ADDENDUM #4

Rye City School District

Issued: 2021-02-17

PROJECT No: 9200
DRAWING BY: Author
CHK BY: Checker
DWG No:
A2-121

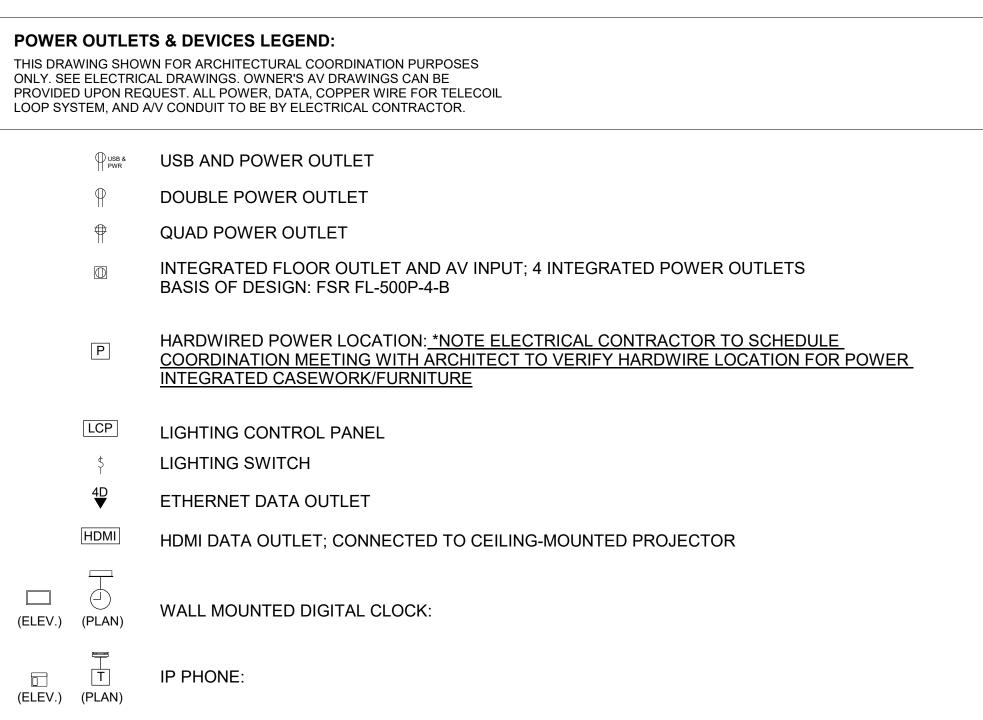
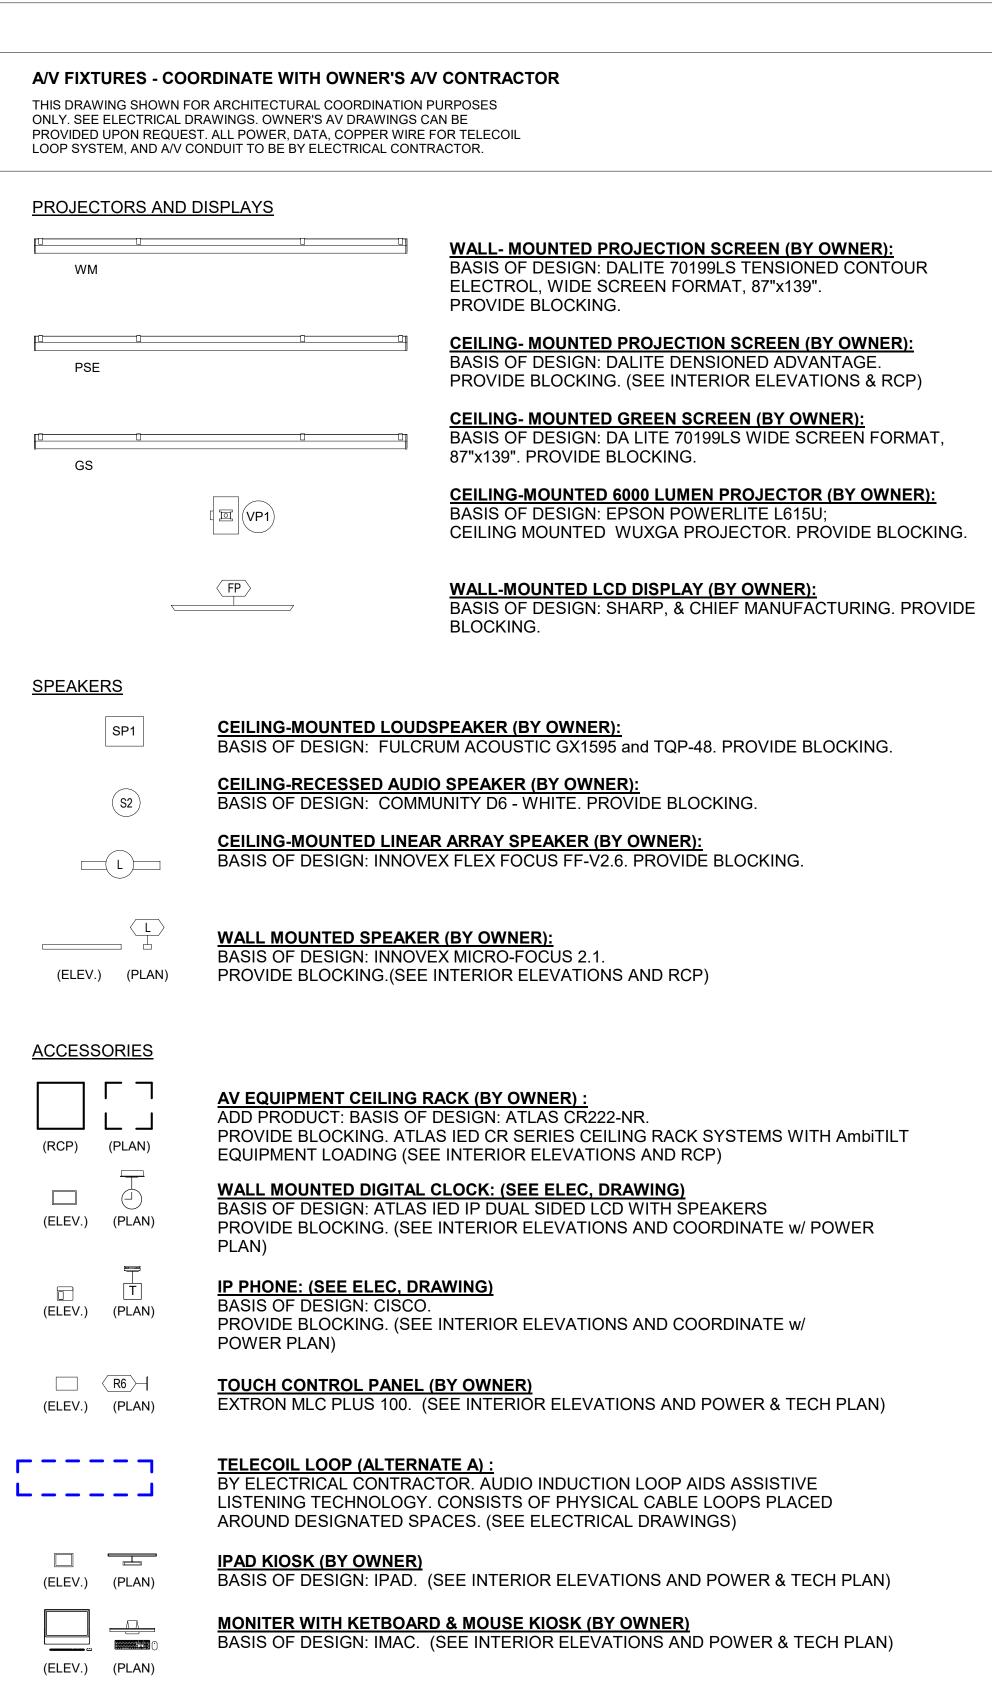
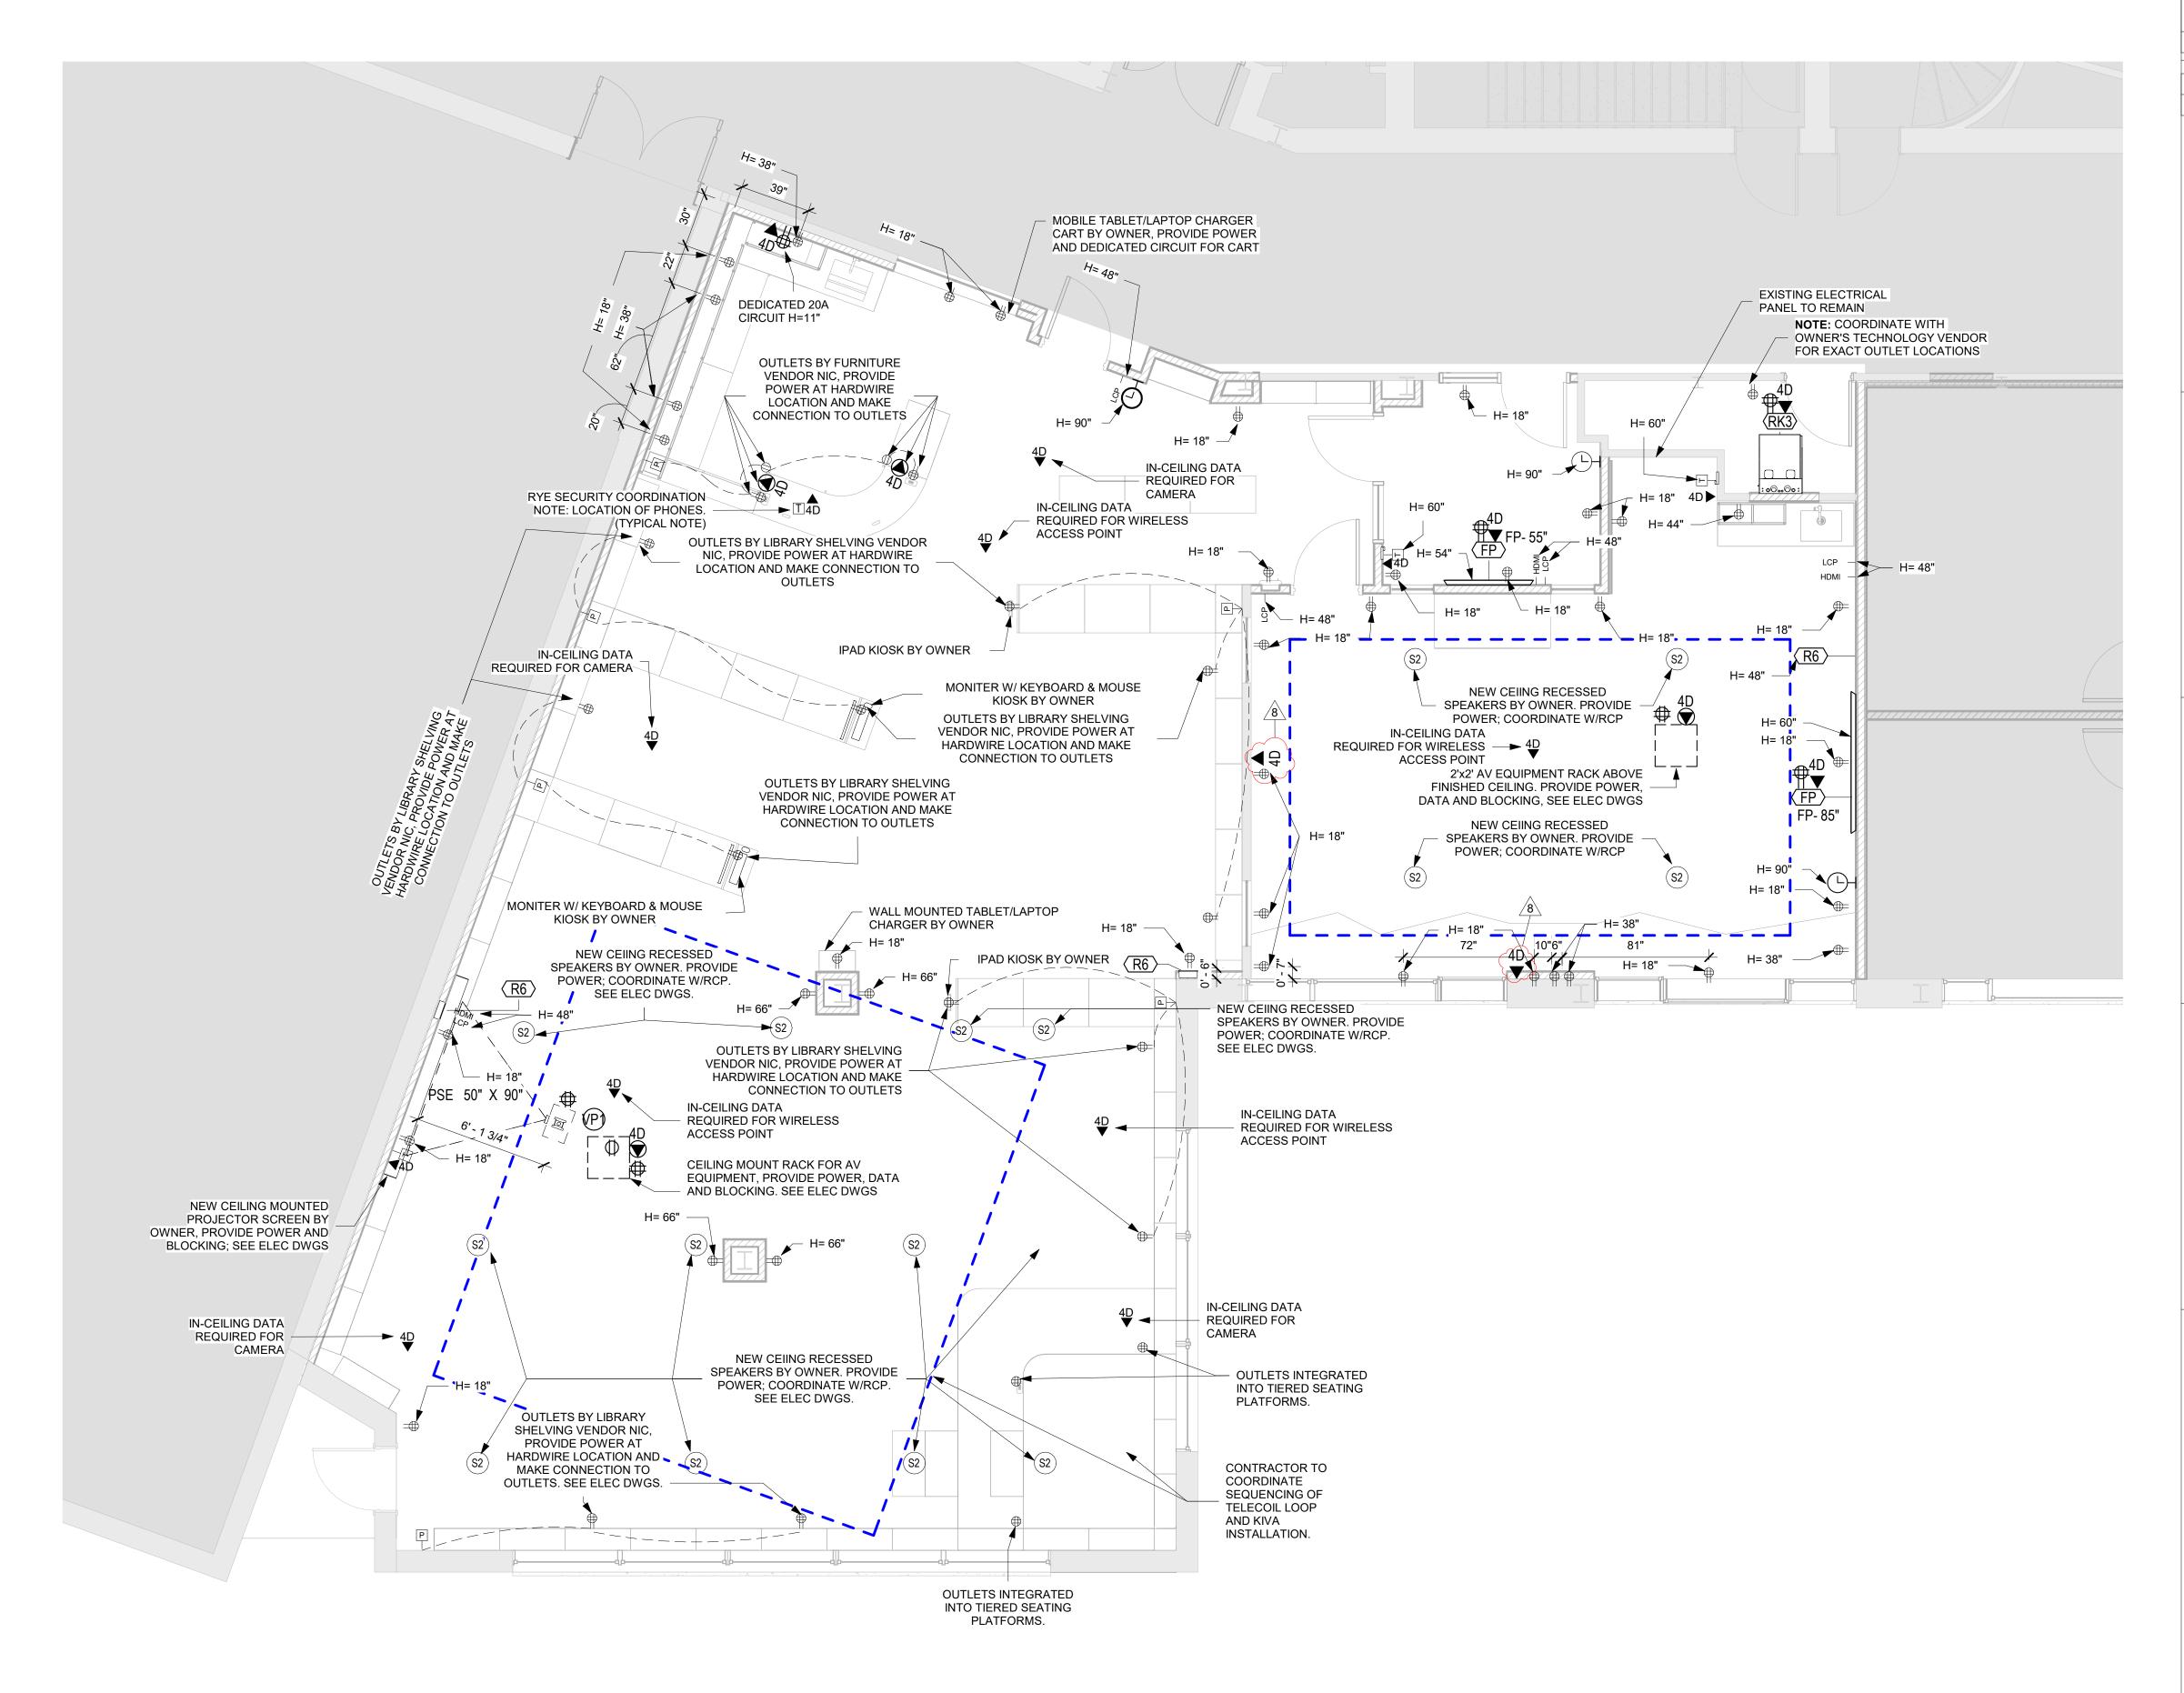
- 1. A2-120 and A2-120A:
 - a. Furring walls added at existing walls as shown.
- 2. A2-121 and A2-121A:
 - a. Data locations added.
- 3. A2-202:
 - a. Window types updated at drawings 4 & 5/A2-202.
- 4. A2-601:
 - a. Door schedule updated to show galvanized steel framing for 45min rated systems.
 - b. Door schedule updated to show hollow metal doors and frames.
- 5. A2-602:
 - a. Door types D-15A and D16 updated.
- 6. A2-700:
 - a. Vinyl wallcoverings to be by GC. Finish legend updated to reflect this.
- 7. A2-730:
 - a. GC to contact architect to receive high-resolution image files of wallcovering designs prior to ordering. Notes added to reflect this.

DRAWING BY: BGA DWG No: E2-104

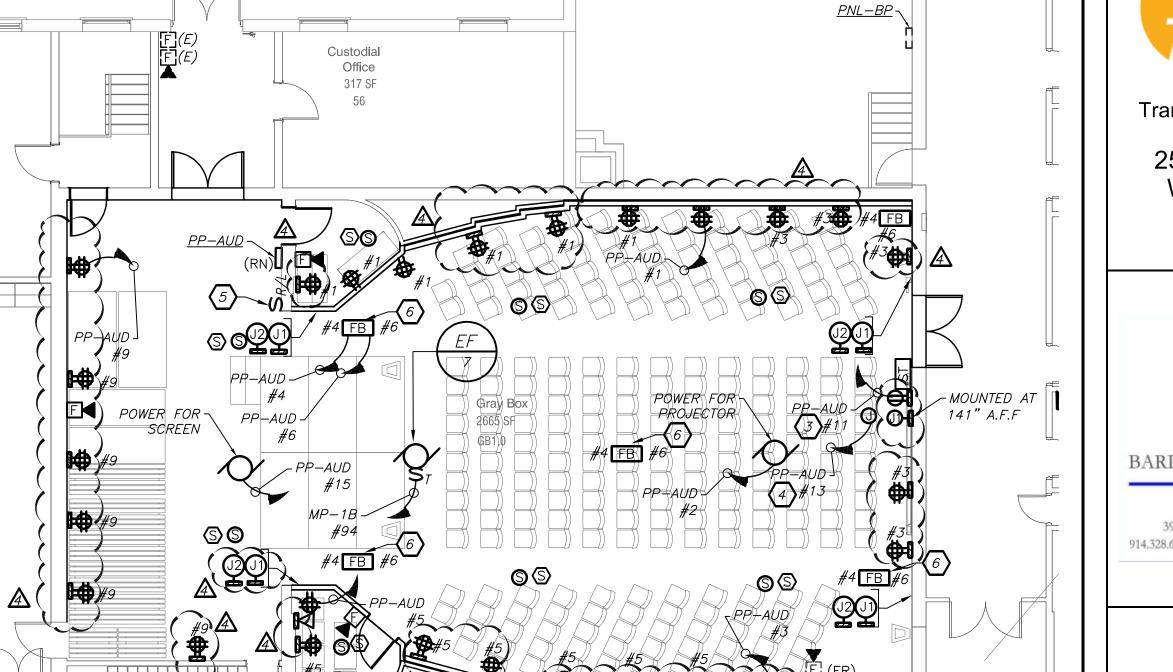
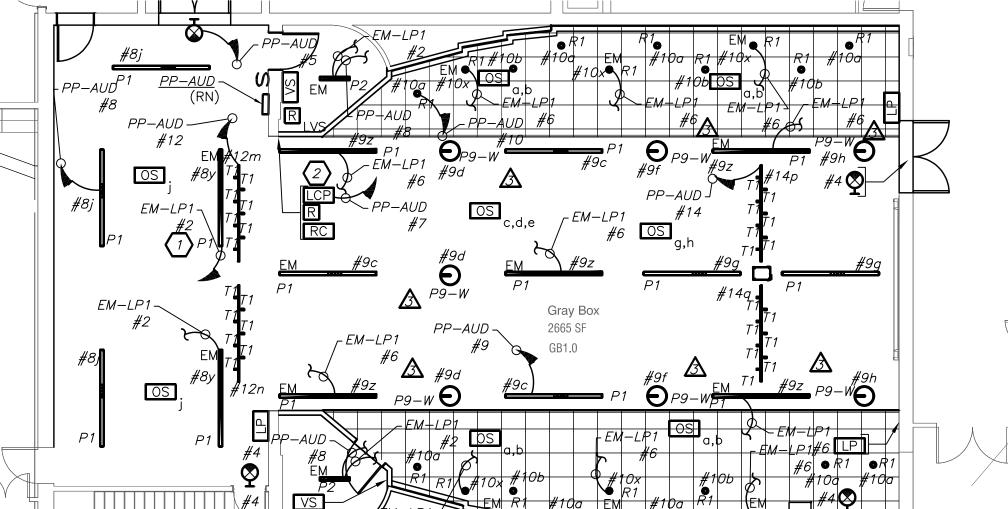
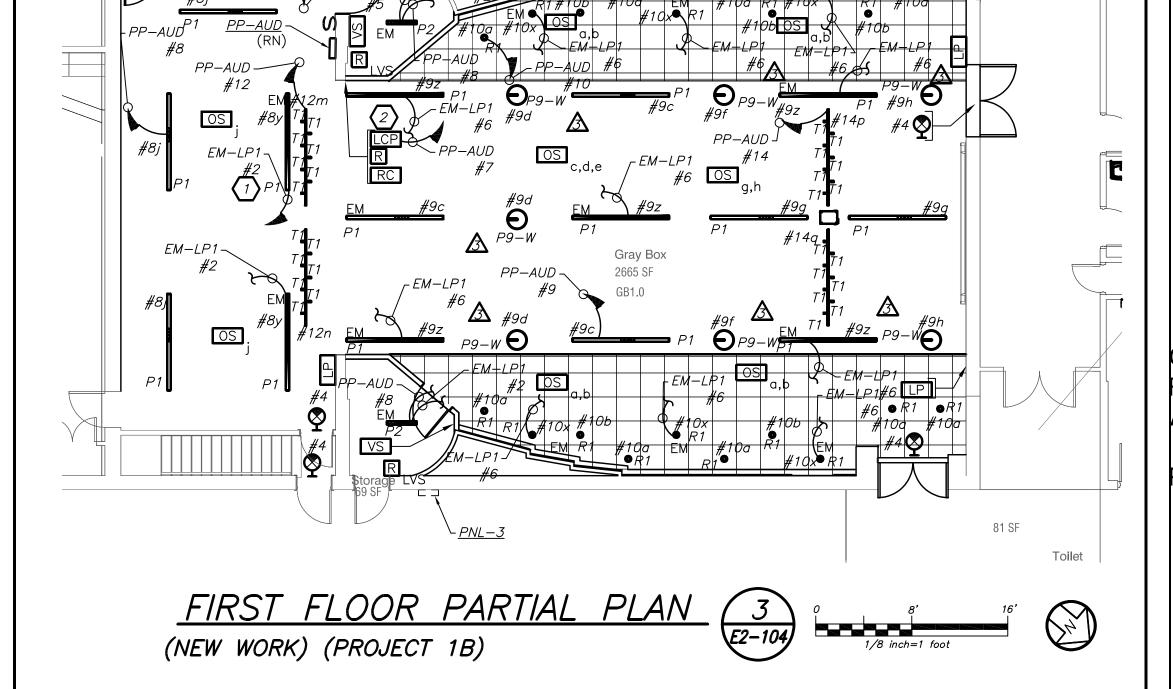
1. E2 – 104 GREY BOX ELECTRICAL REMOVALS, LIGHTING, POWER AND FIRE ALARM PLAN

FIRST FLOOR PARTIAL PLAN 2/E2-104. See attachment.

- a. Provide Wiremold 700 and 2000 on existing walls which are not being furred out. (See Attachment)
- E2-302 PARTIAL FIRST FLOOR POWER AND FIRE ALARM PLAN
